ADDENDUM NO. 02
TO THE CONSTRUCTION DOCUMENTS BID PACKAGE

Client: Arrowhead Regional Medical Center
Project: Oncology-Ambulatory Clinic
SHA Project No.: 18242.100
Date: September 12, 2019

N2 PHYSICIANS OFFICE 037A, B, C TYP.

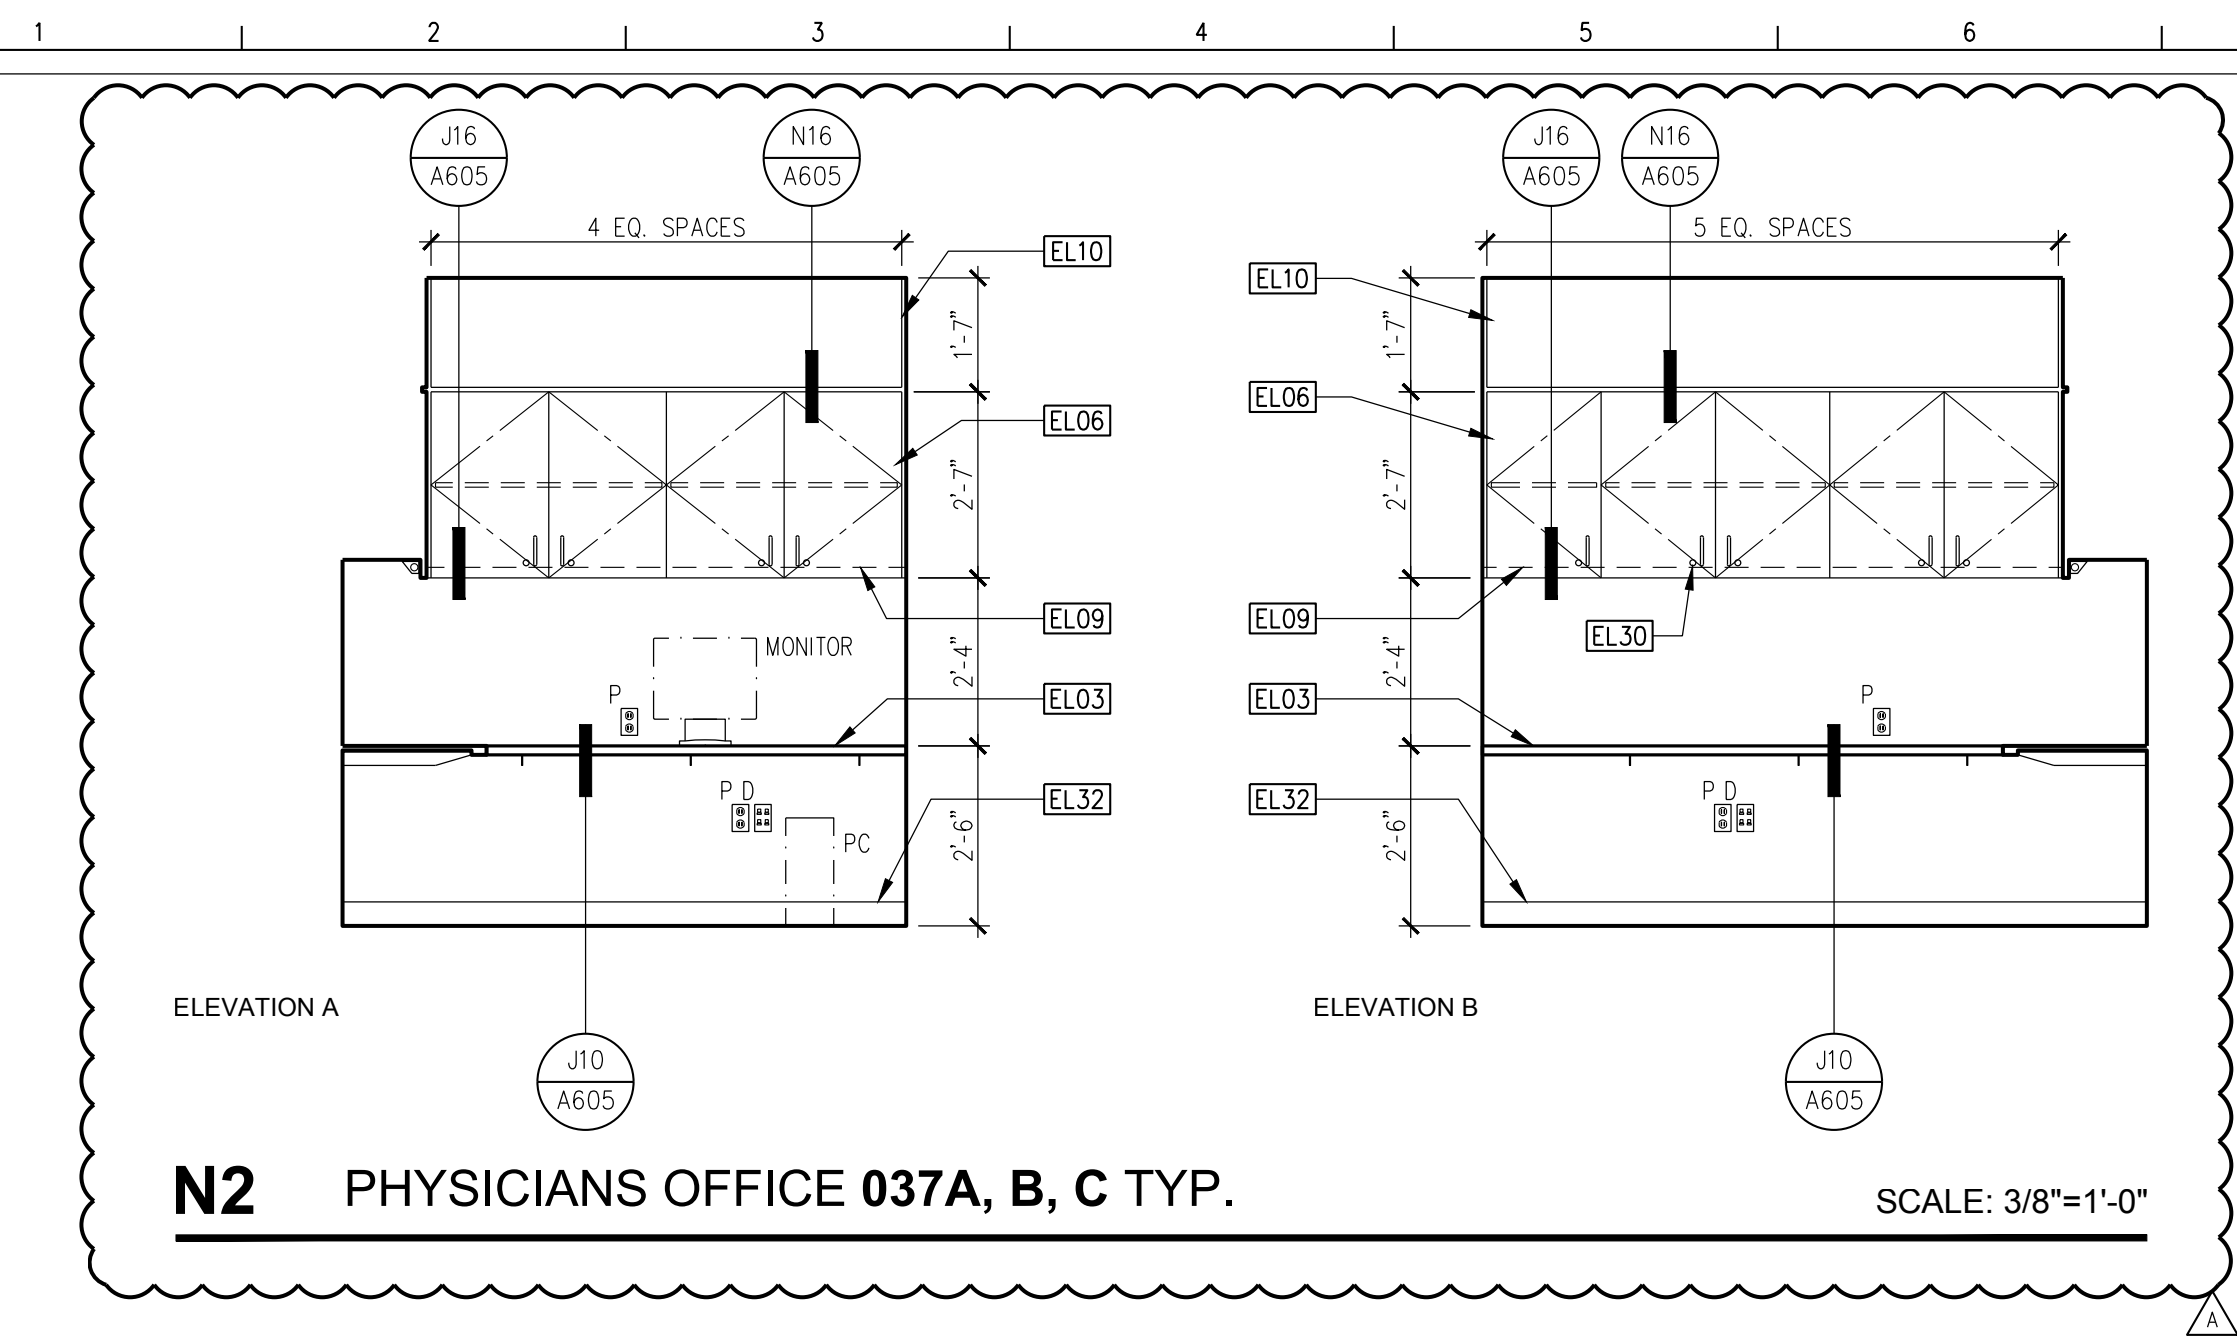
- A202** Physician's Office 037A, B, C Interior Elevations A & B added to sheet at N2/-.
Cabinet locks added to various elevations and Keynote EL30 added to Keynotes.
General Note prohibiting cabinet locks at accessible sink aprons added to General Notes.
Elevation E6 revised to show padlock hasp at plastic laminate lockers.
Elevation J1 revised to match floor plan.
Various detail callouts revised to reference correct detail.
Elevation E2/- added to sheet.

004.1	Elevation E6/A202 shows plastic laminate lockers per Keynote EL02 and Section 105060, but section 090000 Finish Material Legend identifies the lockers as LKR-1 Metal Lockers. Please clarify.	The lockers are to be Plastic Laminate, Metal Lockers have been removed from Specification Section 090000. Please use Specification Section 105060 per architectural drawings. See revised Specification Sections.

- REFER TO EQUIPMENT SCHEDULE FOR MORE INFORMATION ON EQUIPMENT SHOWN ON THIS PLAN AND IN THE EQUIPMENT LIST.
- REFER TO INTERIOR DESIGN DRAWINGS FOR ALL NURSE STATION AND RECEPTION COUNTER CASEWORK DETAILS.
- CABINET LOCKS SHALL NOT BE PROVIDED ON ACCESSIBLE SINK APRONS.

A3 HVAC DEMOLITION PLAN

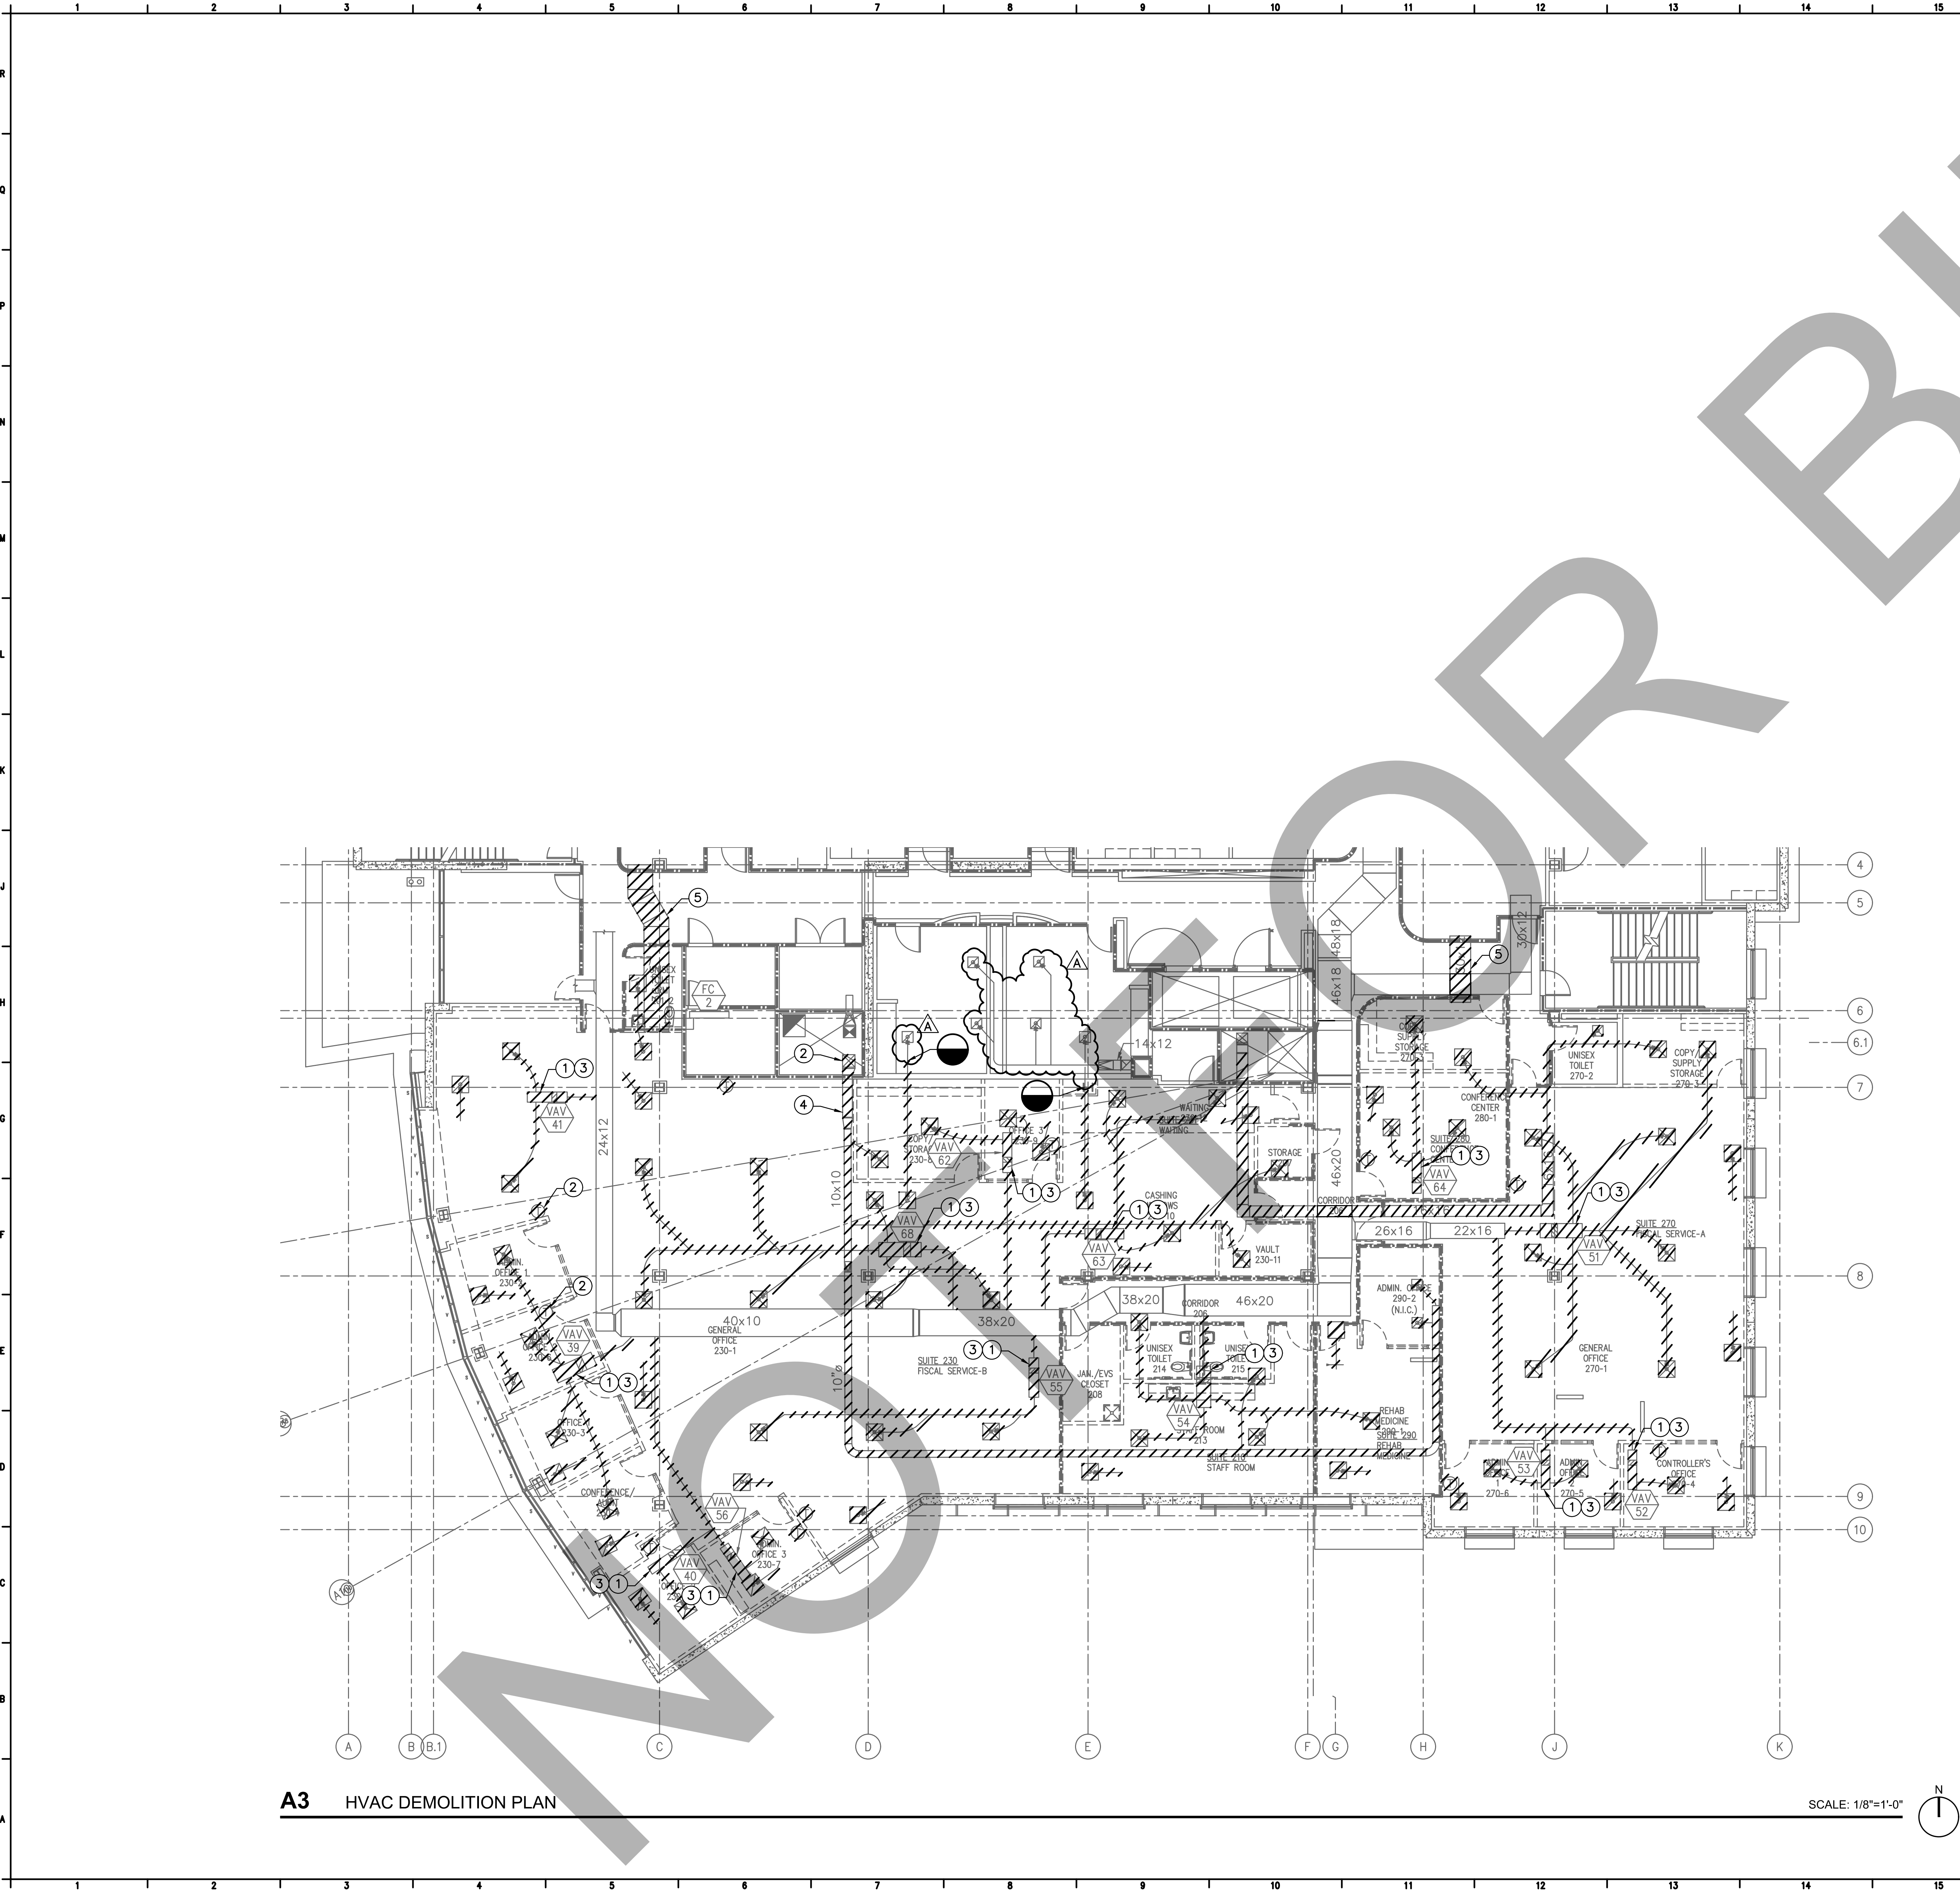
- A605** Revised detail number.
- M111** Revised demolition scope in the existing public restrooms.
- M122** Revised ductwork.
- M125** Added note to sheet regarding patching exterior finishes.
Added General Note #4 referencing framing details.

FLOOR PATTERN AND ACCENT WALL FINISH PLAN 1
SCALE: 3/16" = 1'-0"

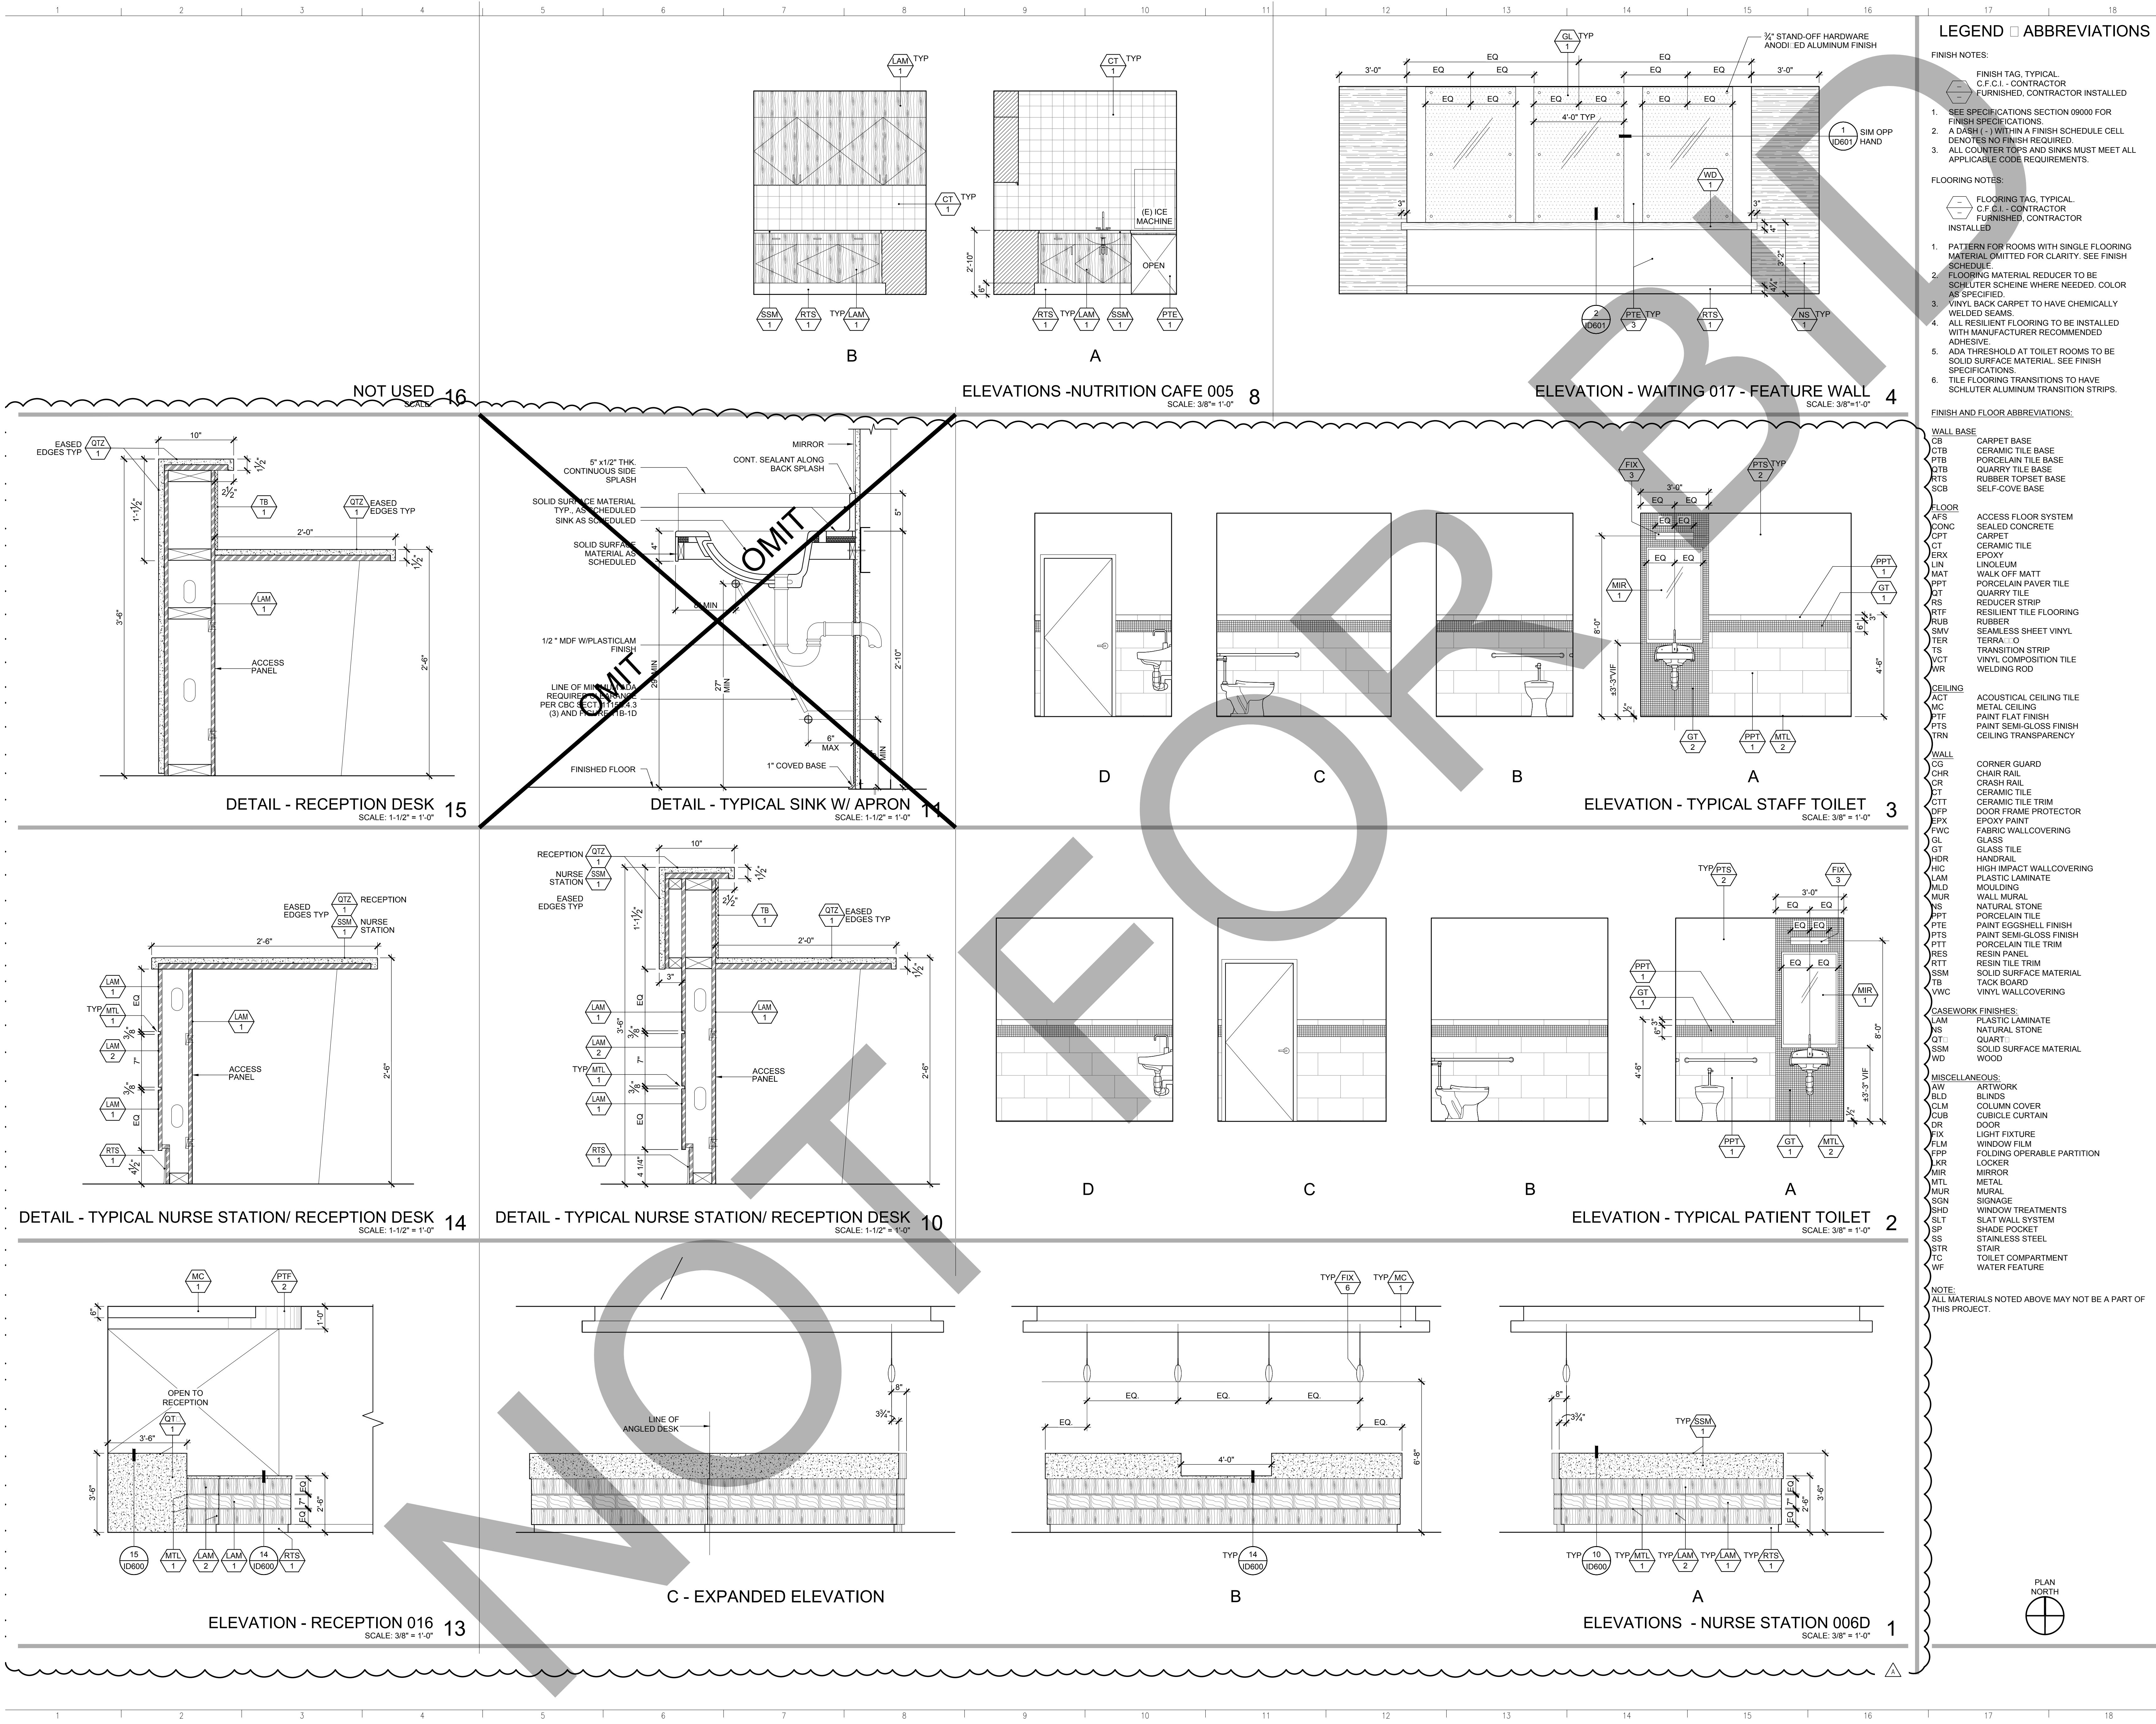
ID300 Added Note to plan regarding Window Treatments.

005.1	Please advise who is responsible for Window Treatment. Specification section 09 00 00 calls for Window Treatment SHD-1 to match building standards, but there are no call outs on the drawings.	Window Treatments are to be contractor furnished/contractor installed. See revised Interior Design drawings and Specification Sections attached.

NOTE: NEW SHD-1 WINDOW TREATMENTS ARE TO BE PLACED IN ALL EXTERIOR WINDOWS TYP
